*Preliminary Consultation*  
**MONTGOMERY COUNTY HISTORIC PRESERVATION COMMISSION**  
**STAFF REPORT**

<b>Address:</b>	15114 Barnesville Road, Boyds	<b>Meeting Date:</b>	10/23/2024
<b>Resource:</b>	Primary (1850-1935) Resource <b>Boyds Historic District</b>	<b>Report Date:</b>	10/16/2024
<b>Applicant:</b>	SRK LLC Jesse Tarr, Agent	<b>Public Notice:</b>	10/9/2024
<b>Review:</b>	Preliminary Consultation	<b>Tax Credit:</b>	Partial
<b>Proposal:</b>	New ADA access, porch alterations, fenestration alterations and other work	<b>Staff:</b>	Laura DiPasquale

The applicant proposes numerous alterations to the property, including construction of an ADA ramp, alterations to the front porch, replacement of select doors and windows, construction of a side deck and egress stairs, installation of new siding, and roof repairs.

**Figure 5: Front (north) and west side elevations, October 2024 (Historic Preservation Office). The red arrow points to the location of the proposed ADA ramp.**

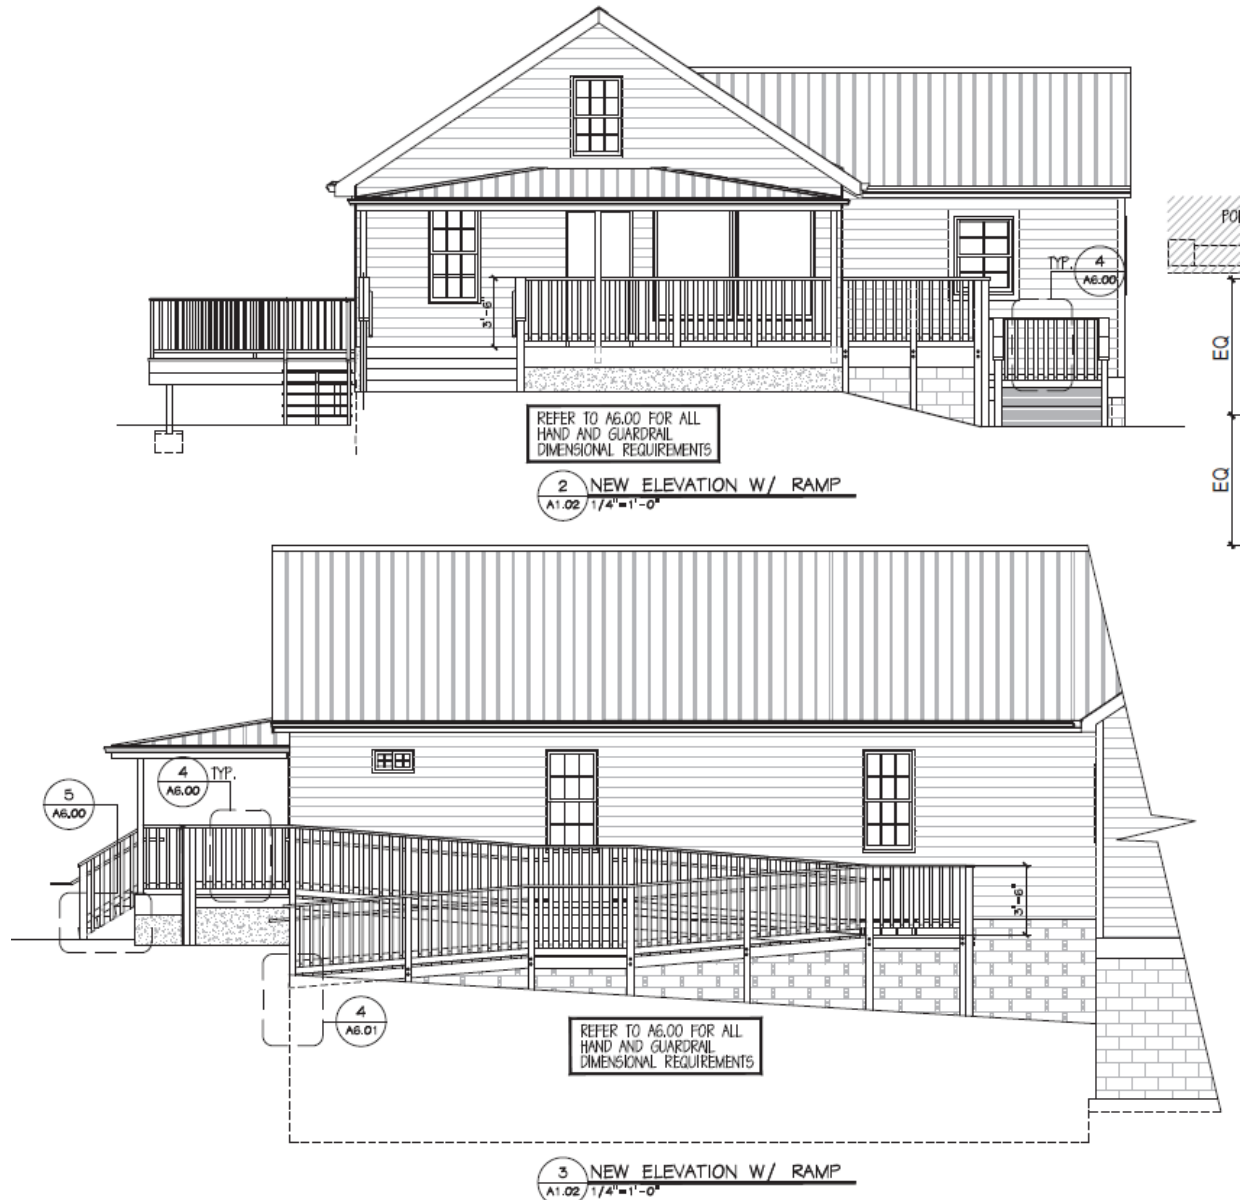
Staff conceptually supports the construction of an ADA ramp or lift, but suggests additional consideration be given to the proposed ramp location and materials. Staff suggests that the applicants explore accessibility options that are less conspicuous than the proposed switchback ramp with its pressure-treated railing and closely-spaced vertical balusters. Other options may include railings without vertical balusters, which would allow for greater transparency, a vertical platform lift, or installation of a small ramp in lieu of the front steps, with minor grading alterations and an ADA-accessible parking space in front of the store.

The Secretary of the Interior’s *Guidelines for Preserving, Rehabilitating, Restoring & Reconstructing Historic Buildings (Guidelines)*, which extrapolates upon the more succinct *Standards*, includes “recommended” and “not recommended” practices as they relate to code-required work. Regarding accessibility, the *Guidelines* recommend “identifying the historic building’s character-defining exterior features, interior spaces, features, and finishes, and features of the site and setting which may be affected by the accessibility code-required work,” “complying with barrier-free access requirements in such a manner that the historic building’s character-defining exterior features...and features of the site and setting are preserved or impacted as little as possible,” and “finding solutions to meet accessibility requirements that minimize the impact of any necessary alteration on the historic building, its site, and setting, such as compatible ramps, paths, and lifts.”<sup>2</sup> Staff finds that, while the proposal limits the removal of historic materials and physical impact to the historic building and could be removed in the future without impairing the essential form and integrity of the property, in keeping with *Standard 10*, the currently-proposed materials and design would have a negative visual impact on the historic resource, failing to satisfy the *Guidelines*, and Chapter 24A-8(b)(2).

*Figure 8: The neighboring Boyd's Country Store shows a similar half-light door with horizontal panels below.*

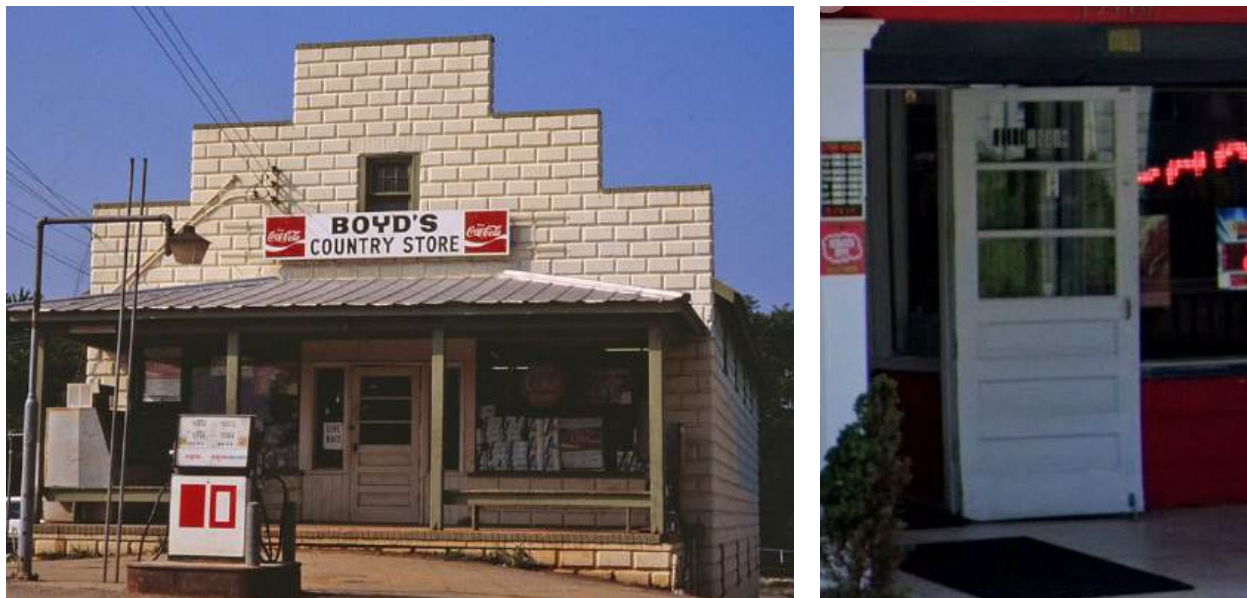
The application proposes to replace the front door, two sets of doors on the west side elevation of the rear addition, and one pair of below-grade doors on the east elevation of the rear addition. The existing non-historic Craftsman style front door was installed between 2012 and 2018 without a HAWP, replacing what appears to have been the original door, or an early, compatible door. Staff finds that neither the existing Craftsman style door nor the proposed Craftsman style front door are compatible with the late-nineteenth/early twentieth century vernacular commercial style of the historic building. Staff suggests that the applicants approximate the appearance of the earlier door, visible in Google Streetview and in the MCAtlas photographs of the property (*Figure 7* and *Figure 9*) from the 1980s, which show a half-light wood door with two horizontal panels below.<sup>3</sup> A similar door can also be found on the neighboring

Boyd's Country Store at 15110 Barnesville Road (*Figure 8*).

Staff finds that the remaining sets of doors to be replaced on the non-historic rear addition are minimally visible from the public right-of-way and do not constitute character-defining features of the building. As such, staff recommends leniency in their review.

Figure 13: West elevation of the rear CMU addition, October 2024 (Historic Preservation Office). Recent window alterations have been undertaken, and additional alterations are proposed.

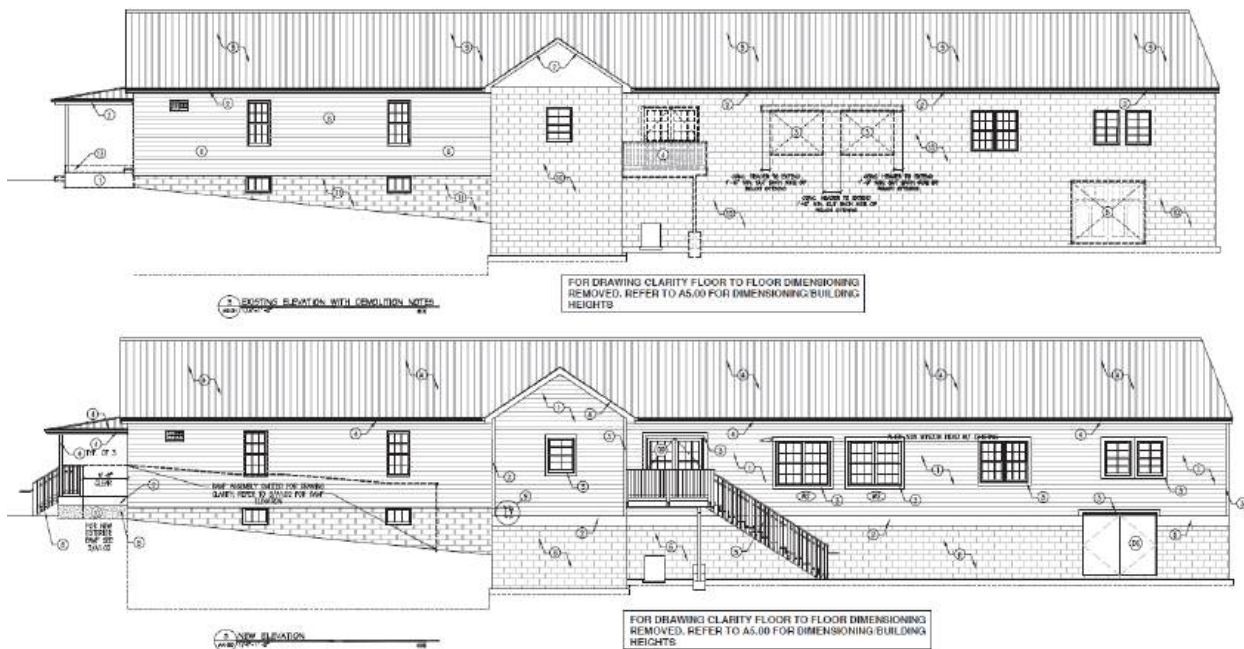
On the west side elevation, the applicants propose to cut two double-width openings and install two sets of windows, shown in the drawings with six-over-six muntin (grille) patterns. No information is provided on the material or other details of these windows, but visibility of the side elevation is limited owing to the projecting side addition and neighboring buildings. The side elevation is obliquely visible from the west along Barnesville Road, and at a distance. Staff supports this alteration, and suggests that six-over-six, two-over-two, or one-over-one windows would be appropriate for this elevation, depending on the applicant's preference.

Figure 16: East elevation drawings (existing/demo above, proposed below) showing the addition of Hardie siding over the CMU rear addition.

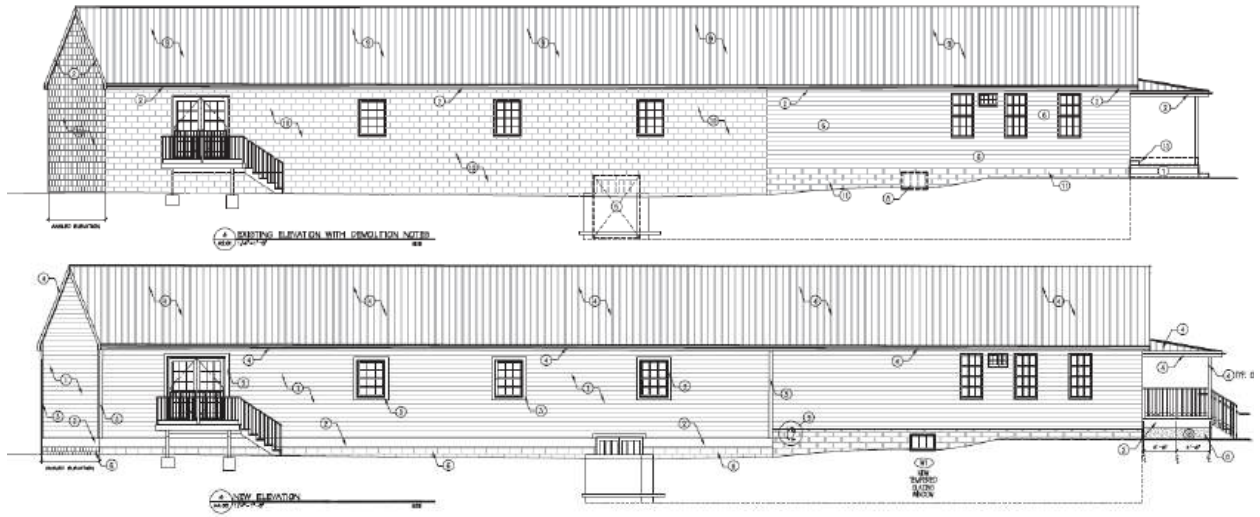
The applicants propose to install new fiber cement Hardie siding over the existing CMU rear addition. New wood trim would be added around the existing and new window openings on the rear addition. Staff does not find that the CMU exterior has any historical significance, and finds that the proposed Hardie siding and wood window trim would be compatible with, but differentiated from, the historic wood clapboard siding, satisfying Chapter 24A-8(b)(2) and *Standard 9*.
